What do we mean by “UNI port”?

- ❑ **Problem statement:** In 1904.4, there is a number of attributes that refer to “UNI port” when they don’t really mean UNI port
 - ❑ Classical definition: User-Network Interface (UNI) is a physical demarcation point between operator’s domain and user domain
- ← In the context of DPoE and SIEPON, UNI port always was a user-facing physical port on an ONU box

Figure 5-3—ONU architecture with single L-ONU (sL-ONU)

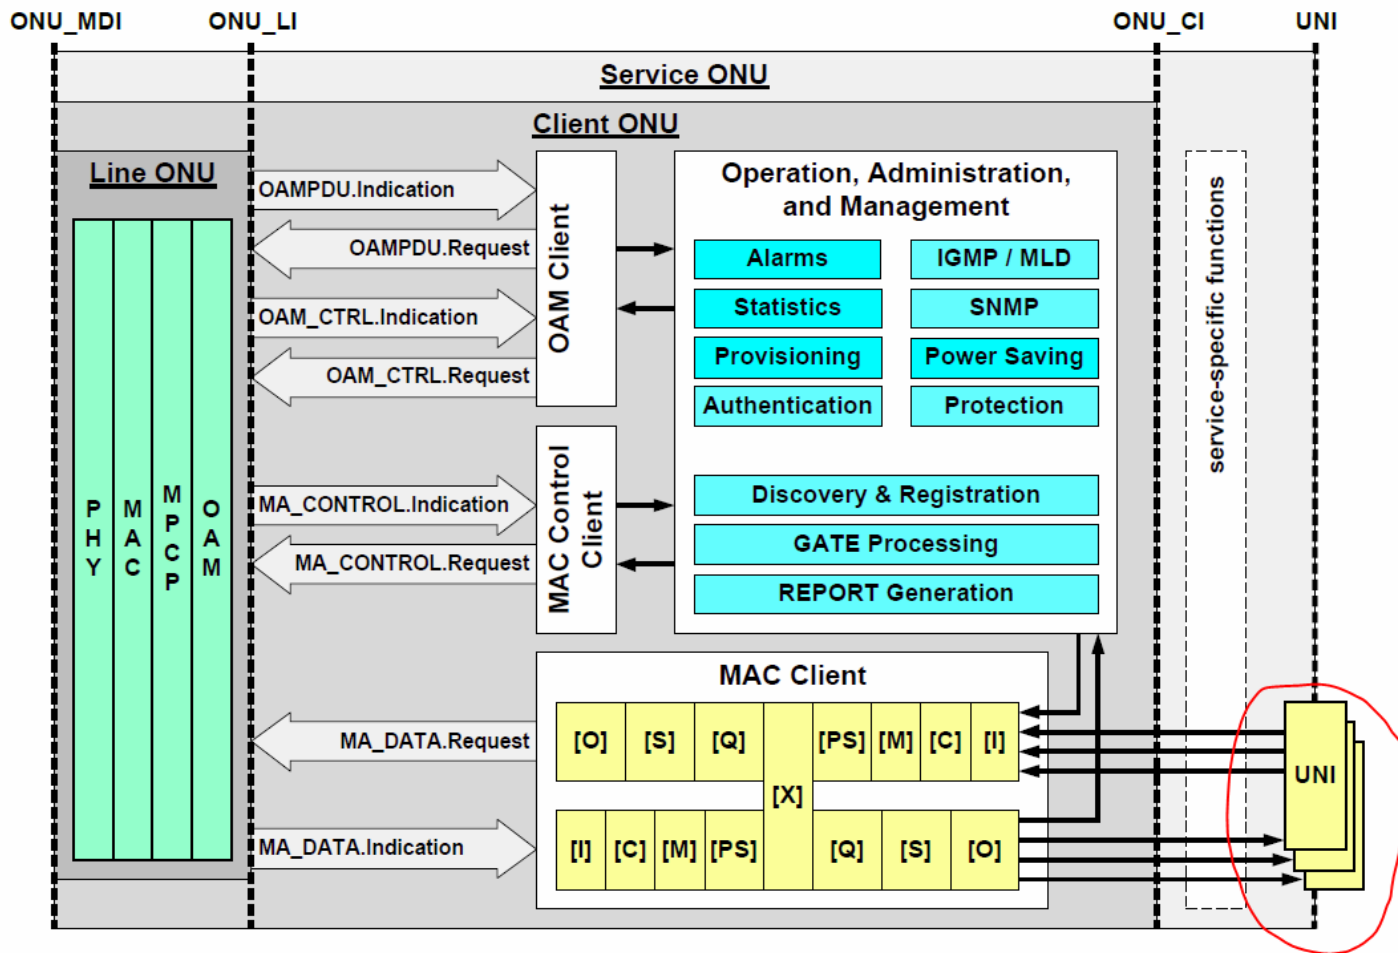
- ❑ Updated ONU architecture figure 5-3 that is aligned with 802.3ca spec
 - 1) 2 channels + MCRS in L-ONU
 - 2) One PLID and one MLID
 - 3) On the user-side, align with DPoE and show eSAFE devices
 - 4) Clearer visual distinction between internal service ports and UNI ports

14.4.3.1.15 Attribute *aOnuUniPortType* (0xDB/0x00-10)

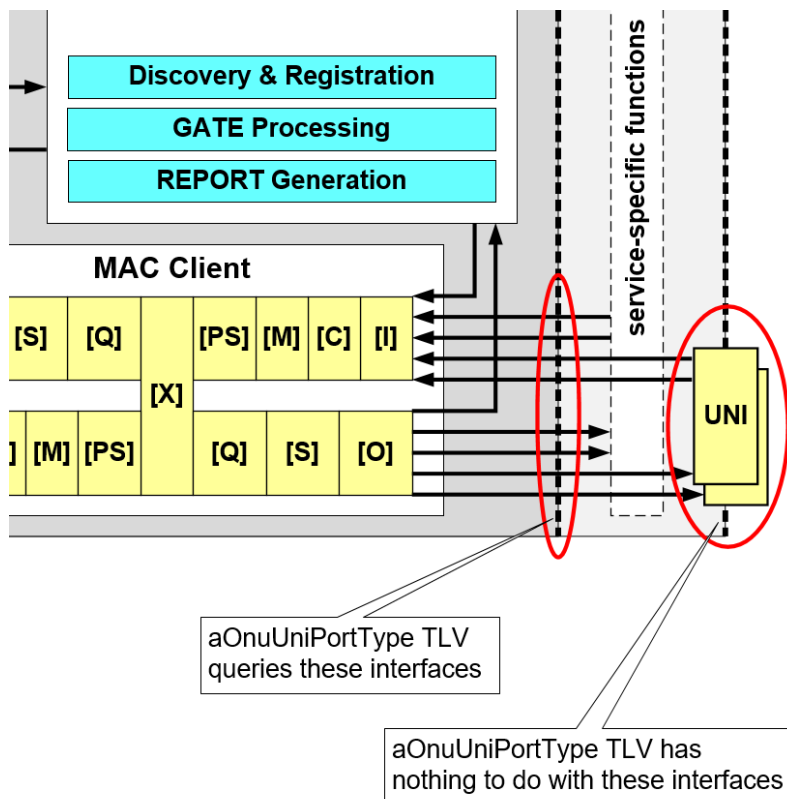
- In D0.3 (as in 1904.1) we have several management attributes that refer to *UNI ports*, while they mean *internal ports*
- The picture below conflicts with the highlighted text

2. Where attribute names use “UNI Port” to mean either an external or an internal port, use term *Service Port (SrvPort)*.

aOnuUniPortType → *aOnuSrvPortType*

acConfigUniPort → *acConfigSrvPort*

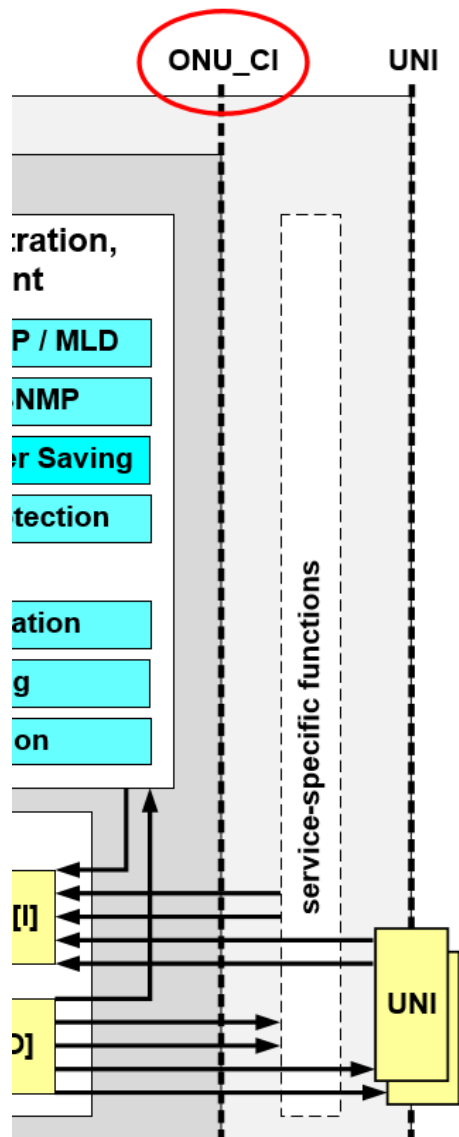
Not 100% accurate. ONU may have a combination of internal and external ports, not either or.

Should not say that. As DPoE S-interface definition says, these internal ports may be just regular GMII/XGMII, i.e., 802.3-compliant.

The ONU_CI represents the interface between the C-ONU and the S-ONU functionalities. The ONU_CI instantiates a number of *service ports*, which may be internal ports connected to embedded service/application functions (sSAFEs) or external ports (i.e., UNI ports) exposed in the S-ONU for connection to physical CPE devices. The ONU_CI corresponds to S-interface defined in DPoE2.0.
